Lambeth Bridge north and south

Response to issues commonly raised
March 2020

Lambeth Bridge Drawing 2

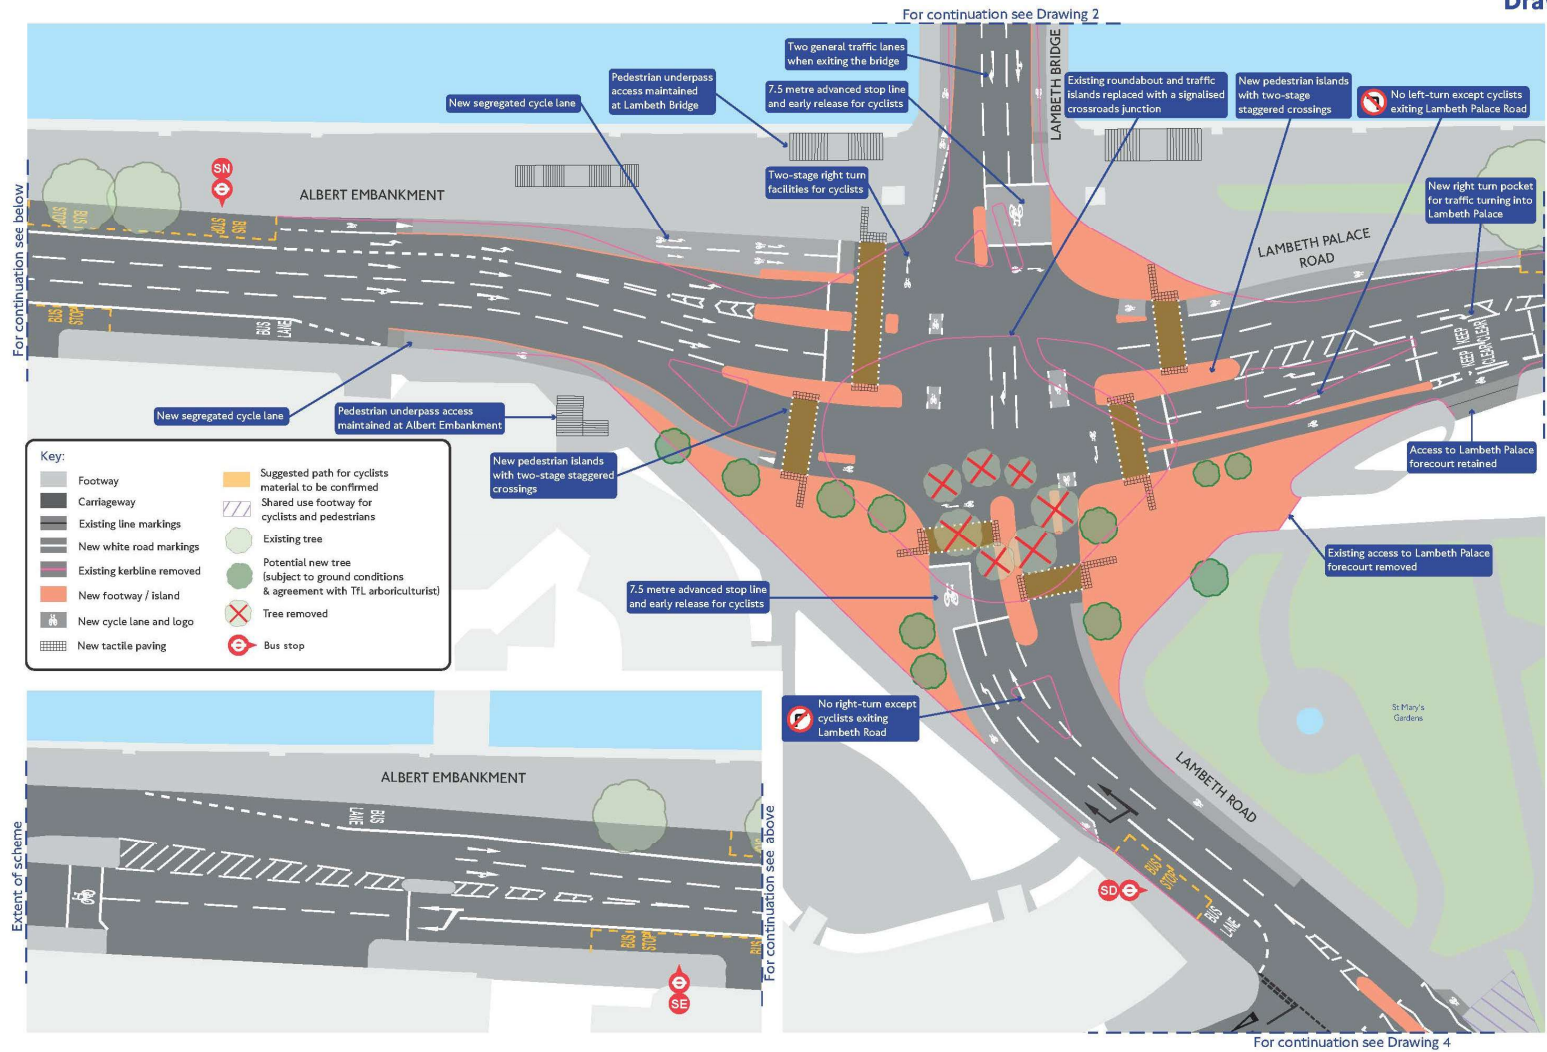
The shared bus and cycle slip lane from Millbank north to Lambeth Bridge looks unsafe for cyclists/cyclists should not have their protection interrupted

This feature has been removed from the design in response to feedback received from the consultation. Under the revised proposals all traffic can now turn left from Millbank north on to Lambeth Bridge. There is now a proposed carriageway level cycle track through this area. Please see Appendix A for the revised design layout.

Lambeth Bridge South Drawing 3

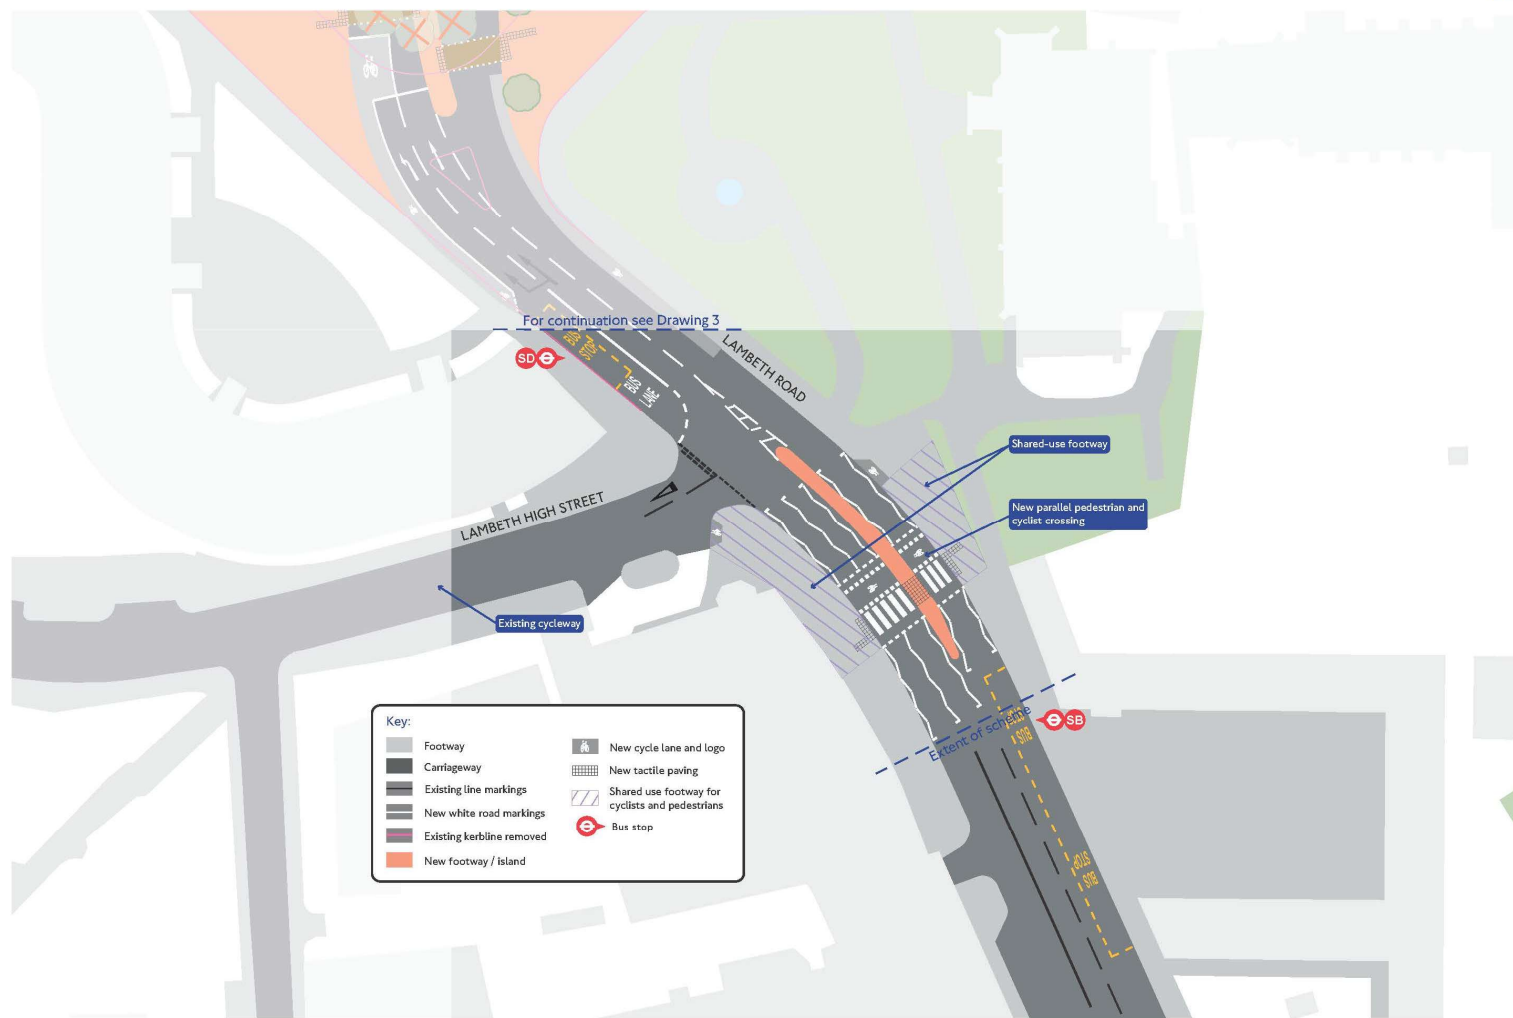
Concern about the lack of vehicle access to Lambeth Palace

Heading eastbound into Lambeth Road - the merged lane arrow should be replaced with hatching from the new pedestrian island to clearly indicate that the road narrows and vehicles do not have two lanes

Access to Lambeth Palace will remain via Lambeth Palace Road. We have amended the design to provide a right turn pocket for vehicles turning into the Palace forecourt as well as 'keep clear' markings. Please see Appendix A for the revised design layout.

Only one lane of traffic enters Lambeth Road at any one time so vehicles will not be two abreast. The merge arrow has therefore been removed from the design. Please see Appendix A for the revised design layout.
